**Item 5.****Development Application: 86-90 Bay Street, Ultimo - D/2026/136**

File Number: D/2026/136

**Summary Recommendation:** This proposal is recommended for refusal.

Figure 24: Separation distances between approved co-living housing to the north (6.4m to 1-3 Smail Street) and within the central courtyard (14m).

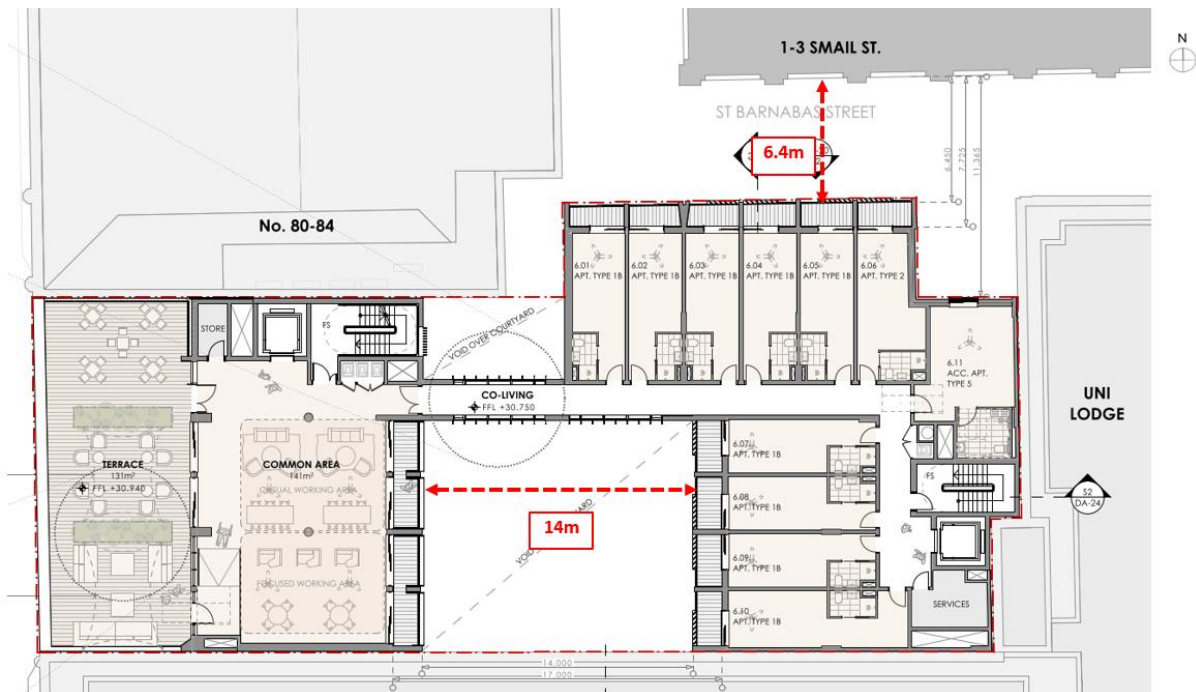
73. North-facing balconies are proposed on the northern boundary at St Barnabus Street. The balconies are located within 6.4m of the south-facing windows for units within an approved co-living housing development at 1-3 Smail Street (Figure 25 below). Within the development, proposed eastern and western balconies are separated by approximately 14m, which constitutes a non-compliance of 4m (22%).

74. St Barnabus Street is approximately 6m wide. To comply with the standard, north-facing balconies of the development are required to be setback by 6m from the northern property boundary. This measurement consists of 3m (as measured from the centreline of St Barnabus Street, which is 6m wide) and an additional 6m to provide for the minimum 9m site 'shared' contribution required by the standard - half of 18m.

- 80. The lack of building separation results in a development that will provide low residential amenity for future residents. In this regard, the proposal fails to satisfy the objectives, which are to ensure new development is scaled to support the desired future character with appropriate massing and spaces between buildings, and to provide residential amenity including visual and acoustic privacy, natural ventilation, sunlight and daylight access and outlook.

Figure 25: Raised planter beds limit useful spaces within the ground level communal courtyard.

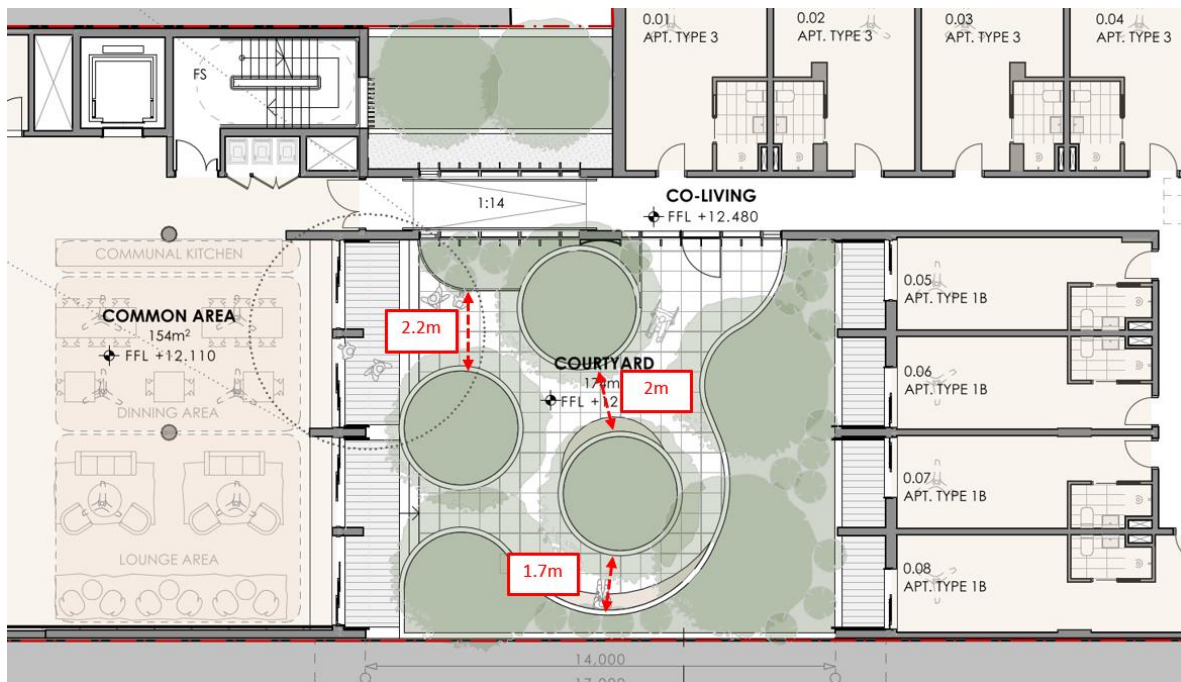
89. The ground level courtyard has been designed with raised planter beds rather than with planting at grade. The planter beds divide the space into small spaces that are not useful for communal activities (Figure 26 below). As such the Level 6 terrace would be expected to carry much of the communal open space burden of the development.

90. The space is undersized for 137 units. Further, water harvesting and reuse is proposed, however no tanks are shown for irrigation with only an OSD tank provided. As such, the design fails to satisfy Clause 6.21(2)(d)(xiii) with regard for excellence and integration of landscape design.
